# UNITED STATES PATENT AND TRADEMARK OFFICE

APPLICATION NO.	FILING DATE	FIRST NAMED INVENTOR	ATTORNEY DOCKET NO.	CONFIRMATION NO.
10/734,424	12/12/2003	Bernhard Sander	DT-6716	3920

## Office Action Summary

## DETAILED ACTION

FIG. 2

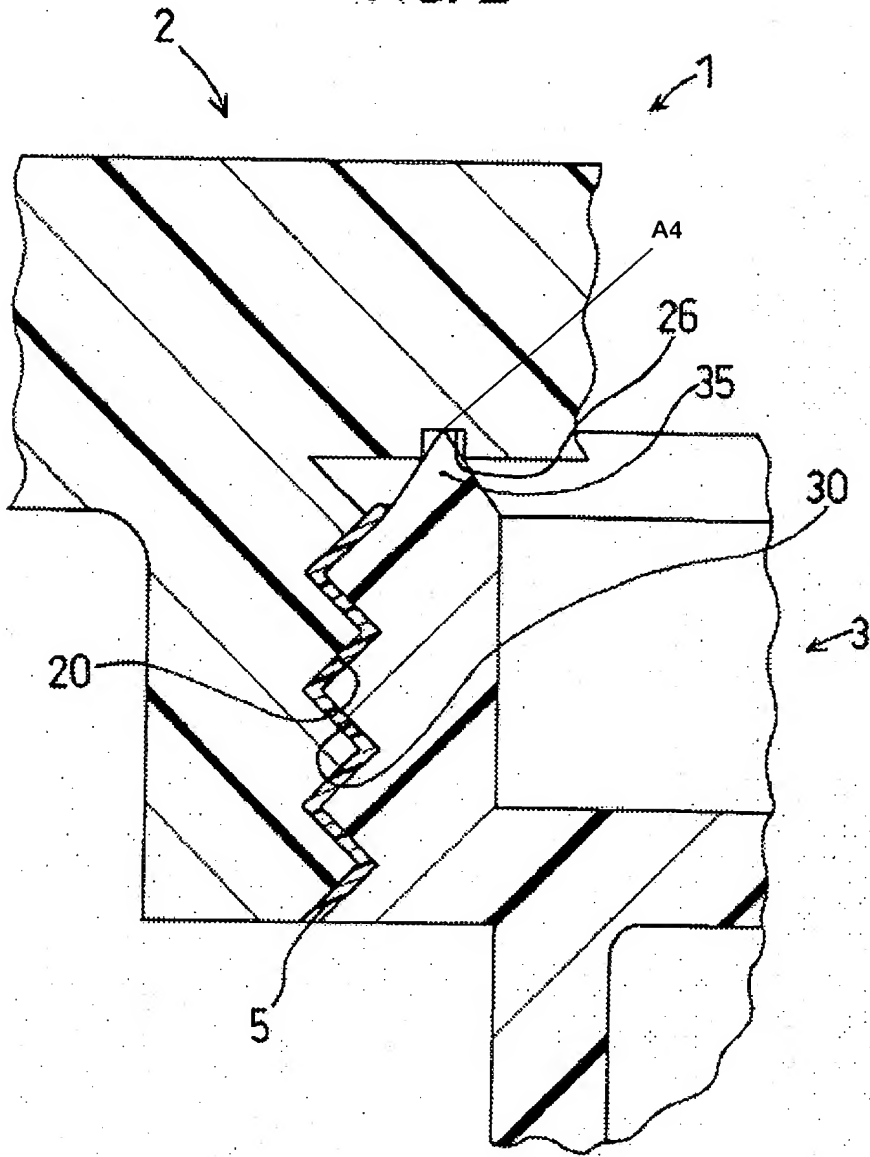
Regarding claim 1, Aoki et al. disclose, in Figure 2, a coupling between a tool receptacle **1** and a tool **2** with two oppositely directed contact means **26,35** facing one another. At least one of the contact means **26,35** has a pointform **A4**.

Regarding claim 7, Aoki et al. disclose the coupling in combination with a pre-stressing means **5,20,30**,. The pre-stressing means **5,20,30**, comprises an axially directed screw-thread biasing member **5**.

Regarding claim 8, the screw-thread biasing member extends axially from the tool receptacle **1** into a threaded bore **20** extending axially into the tool **2**.

**Fig. 2**

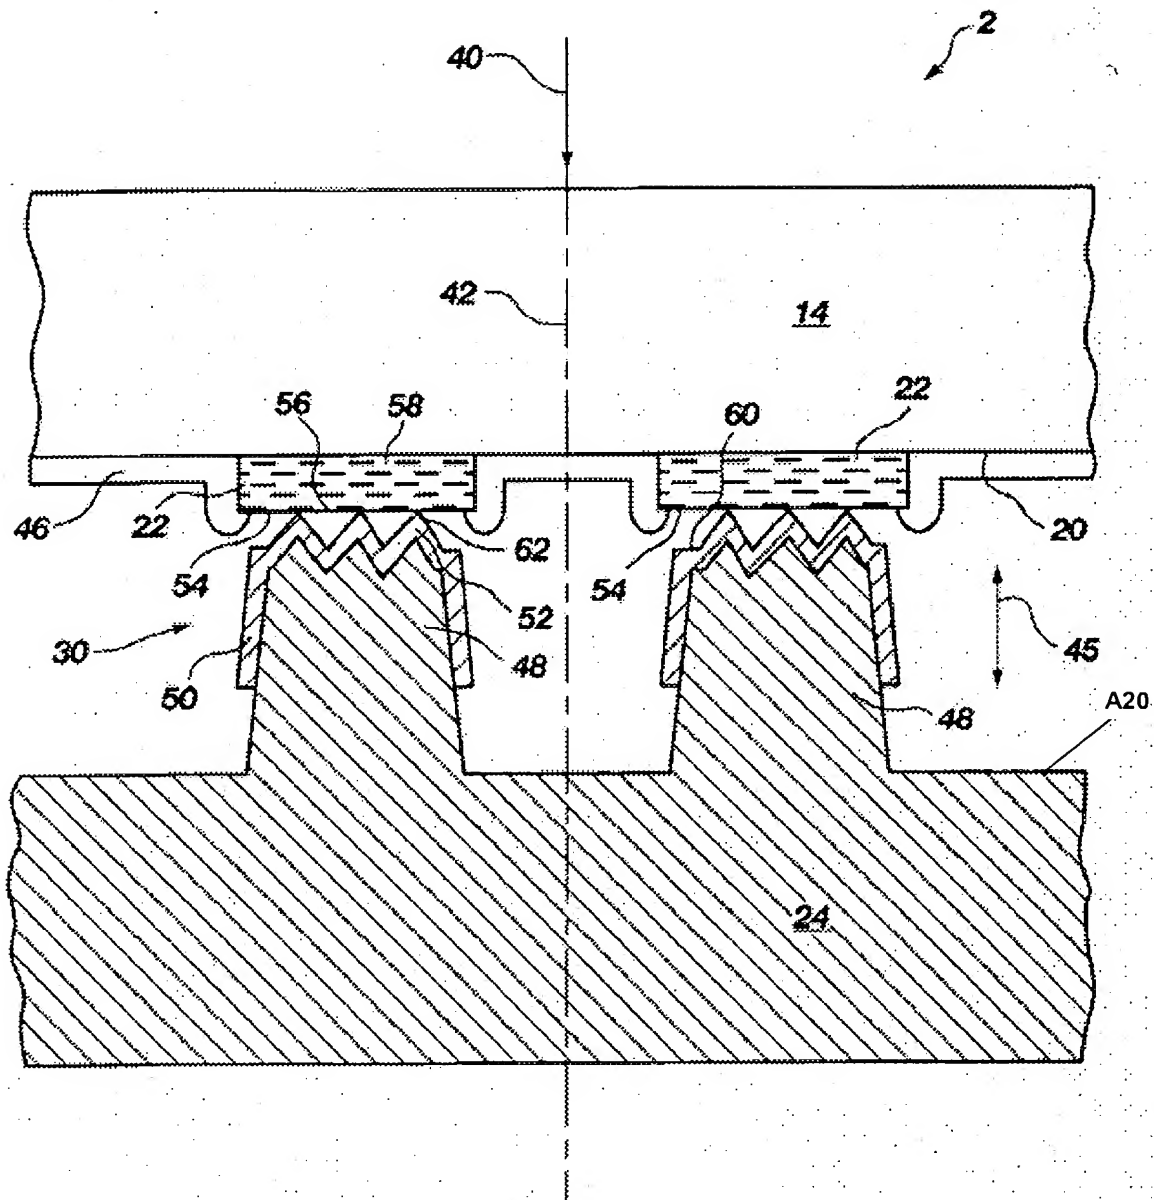
Regarding claim 1, Hembree et al. disclose, in Figure 2, a coupling between a tool receptacle **24** and a tool **14** with two oppositely directed contact means **20,A20** facing one another. At least one of the contact means **A20** has a pointform **48**.

Regarding claim 2, contact tips **52** are spaced apart forming the --at least one-- contact means **20,A20**.
